ONSITE SEWAGE DISPOSAL SYSTEM

PROPERTY ADDRESS: 2178 Millers Mill Road

PERMIT PLAN
2178 MILLERS MILL ROAD

BAT SITE PLAN
 2178 MILLERS MILL ROAD
 TAX MAP #14 GRID #4 PARCEL: 26
 ZONED: RC-DEO
 FOURTH ELECTION DISTRICT HOWARD COUNTY, MARYLAND
 SCALE: 1" = 30' DATE: FEBRUARY, 2019
 SHEET 1 OF 2

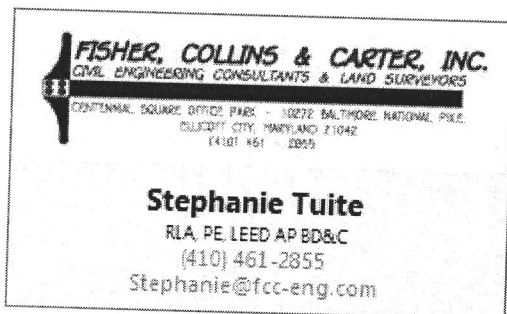
I reviewed the revised BAT plan and the calculations are not correct. The new lateral design has 9 perforations for lateral 1A, which equals a lateral flow rate of 14.67. Your chart equates that to a 0.54 flow per linear foot, but the actual flow per linear foot by dividing 14.67 by the 41 foot trench length is 0.36. That is a 37% difference in flow rate from the highest flow trench, 1D.

Is there a reason why you didn't redesign the laterals based on my recommendation from $\frac{1}{4}$, which would have lowered trench 1D to keep the stone depth more than 6" below the surface and would have evened up the flow rates to with 2% of each other?
